Thank you for contacting the City of Sammamish regarding the current Shoreline Substantial Development Permit Application for East Lake Sammamish Trail Segment 2B (SSDP2016-00415).

Thank you for requesting permit feedback for of the ELST section 2b 60% plans. Our property titled under Emily B. Kruglick (maiden name) shares its eastern property line with the trail corridor. We would like to provide feedback in 6 areas:

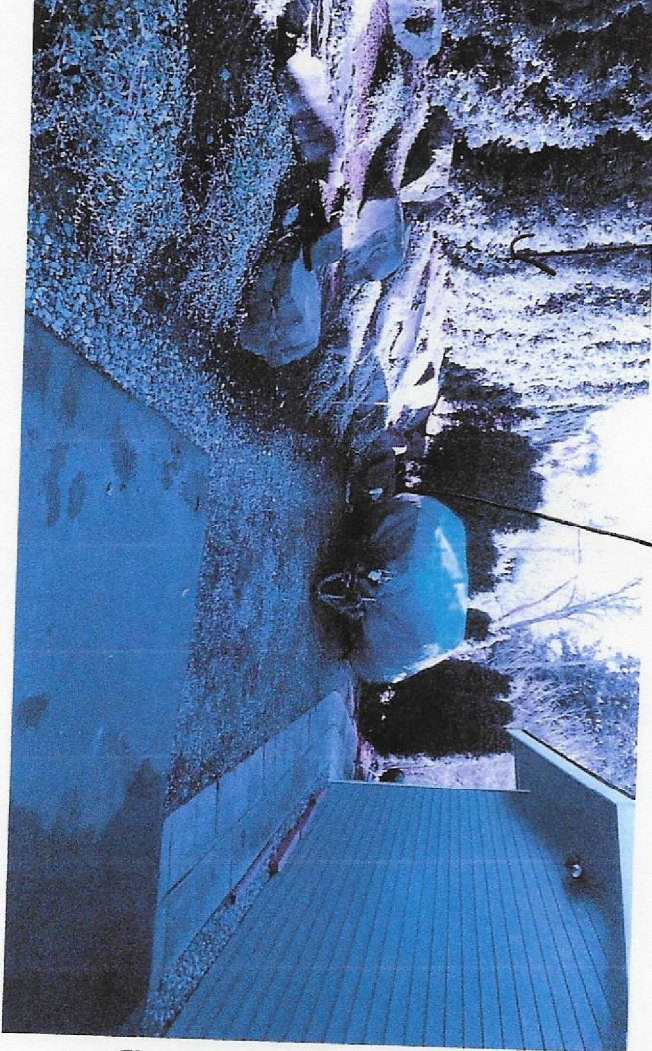
6) Correction to the Tree Preservation plan that SE 26<sup>th</sup> is a private road

On the tree preservation plan, it notes SE 26th (Driveway 5) as a public driveway. On the 60% plans it is correctly marked as private. SE 26th is a private road and is not to be used for construction or trial access.

**Request:** We would like the tree preservation plan to correctly state that it is private not public.

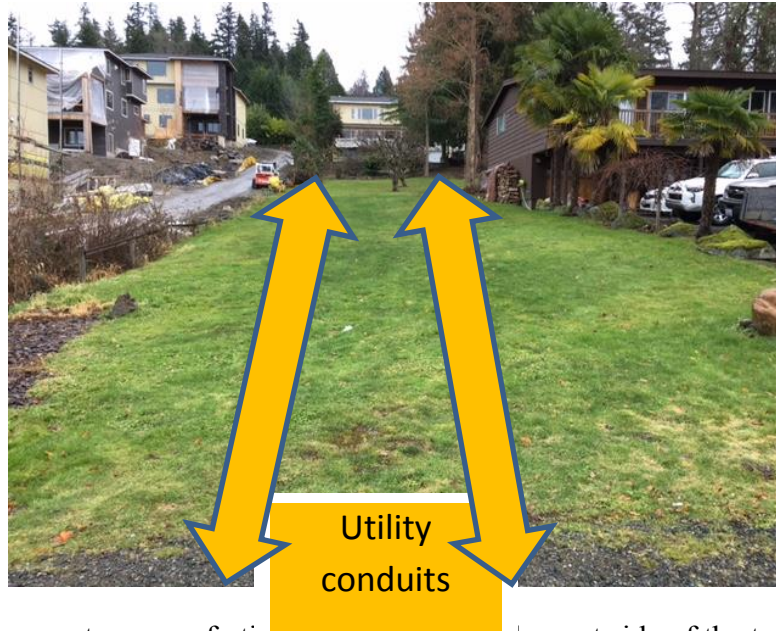
- d. It is unclear how deep below the current ground surface the wall (or wall footings) will go?
- *Please describe what measures will be taken to avoid damage to our utility conduits and what measures will be taken to ensure continuous service before, during and after construction.*

**e. HOMEOWNER RECOMMENDATION: THE AREA OF STAIR #30 AND THE WESTERN HILLSIDE IS OUTSIDE OF THE PROPOSED TRAIL EDGES AND SHOULD BE EXCLUDED FROM THE CURRENT CG AREA. THIS WILL AVOID SEVERAL MAJOR POTENTIAL PROBLEMS.**

- **Keeping this area outside of the CG area will avoid damage to the concrete stairs, retaining wall, utility conduits, Shoreline Restoration mitigation plantings, sprinkler system and heads and landscape lighting electric wires.**

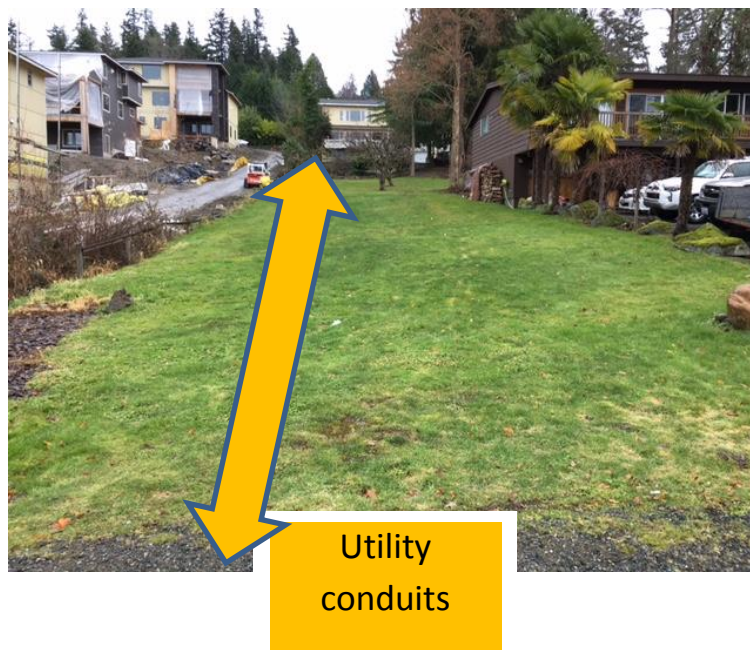
b. Two separate areas of utility conduits lie on the east side of the trail in the CG fence zone. It is unclear whether posts will be placed deep into the ground for the fencing, thus putting our utility conduits in danger of being damaged.

➤ *Please describe what measures will be taken to avoid damage to our utility conduits during the CG fence placement phase.*
